SERVICE BULLETIN

REFERENCE ENGINE _____
NUMBER 011
DATE 10-20-89
MODEL RN

22R-E, 22R-TE HARD STARTING/ROUGH IDLE

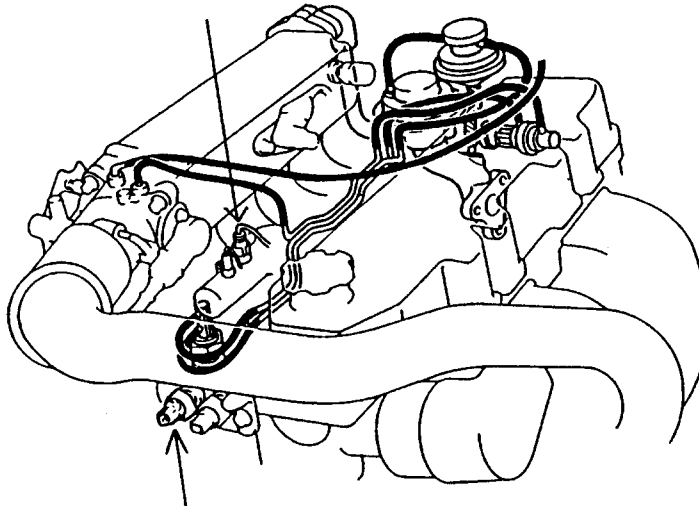
1. Replace cold start injector time switch with the new part.
2. On vehicles equipped with a pressure-up system, (see application chart on page 1) also replace Temperature Switch No. 2 with the modified one.

CONDITION DESCRIPTION	IMPROVEMENT
1 Hard Starting/Rough Idle after a Hot Dead Soak of 15-30 minutes.	Reduce the temperature where Temperature Switch No. 2 activates the fuel pressure-up system from 110°C (230°F) to 60°C (140°F).
2 Hard Start/Long Crank Time after an extended dead soak of 3 to 4 hours.	Increase temperature at which the Start Injector Time Switch activates the cold start injector from 35°C (95°F) to 45°C (113°F).

HOW TO REMOVE THE WIRE TERMINAL

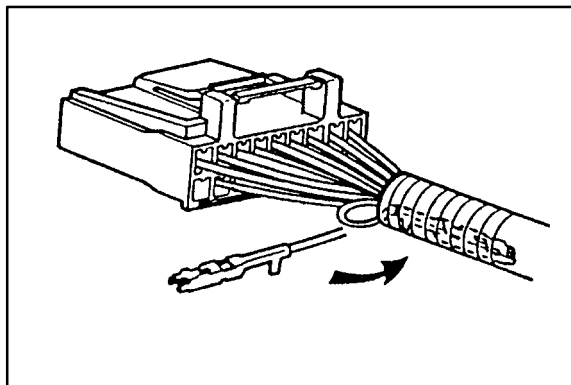
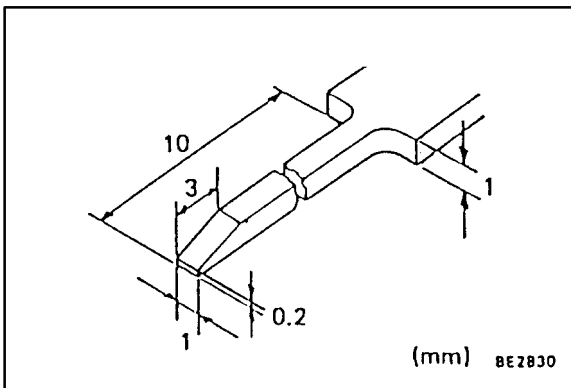
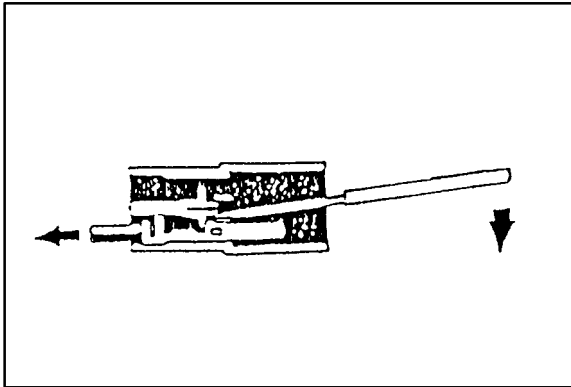
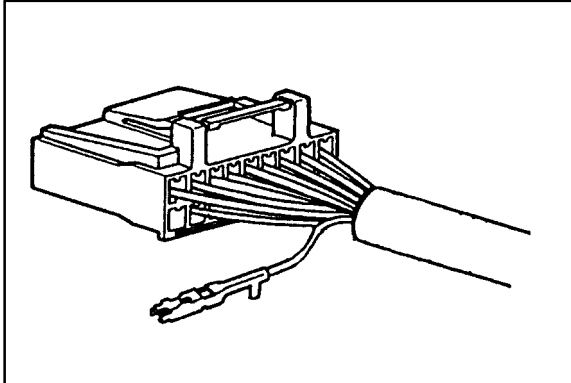
3. For vehicles equipped with Air Conditioning, the ACV terminal must be disconnected from the ECU when installing the modified Temperature Switch No. 2 (Condition 1). This is necessary to prevent the Engine Idle-Up from working continuously after warm-up.

1. Insert a miniature screwdriver from the open end. Move the locking clip to the unlocking direction () and hold it in this position.

2. Carefully remove the terminal without using excessive force.

3. Wrap the removed wire terminal with electrical tape. Tuck the terminal into the harness protector and secure with electrical tape.
